Work Order ID 100351

Item Name: Replacement Skidtube

DRAWING NO. D2650		208407 SKIDTUBE ASSEMBLY		DART AEROSPACE LTD ENGINEERING ORDER		D2650-1-1	
DRAWN		CHECKED		MFG APPR.		APPROVED	
DATE 12.10.12		DATE 12.10.22		DATE 12.10.22		DATE 12.10.22

CHANGE C'BORED WELDED CROSSBOLT SPACERS TO SWAGED SPACERS

DETAIL G

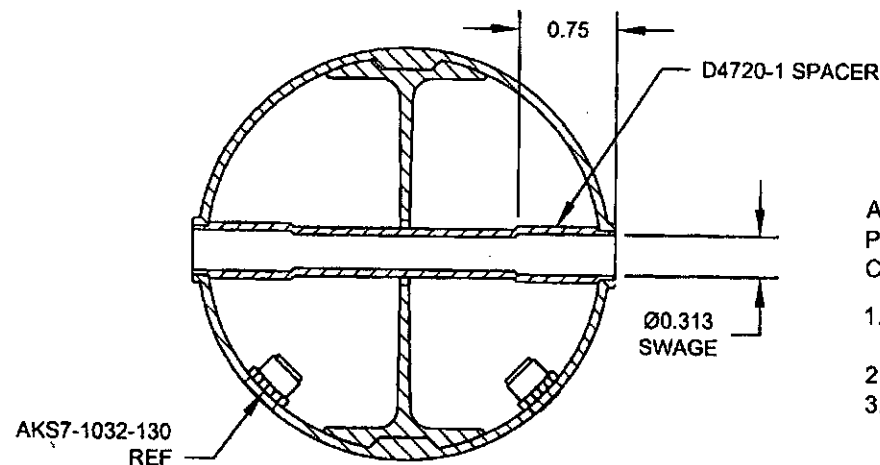
ADD DETAIL G BELOW, WHICH IS THE SAME SECTION VIEW AS DETAIL D OF DWG.

C'BORED HOLES ARE NOW SWAGED PER DETAIL G BELOW. FOR THE Ø0.375 HOLE THAT IS NOT C'BORED, WELD PER DETAIL D OF DWG (SEE AMENDED DETAIL B FOR REFERENCE).

D2649 SPACER,
WELD PER DETAIL D OF DWG
BUT DO NOT C'BORE

AMENDMENT TO DETAIL B
NOT TO SCALE
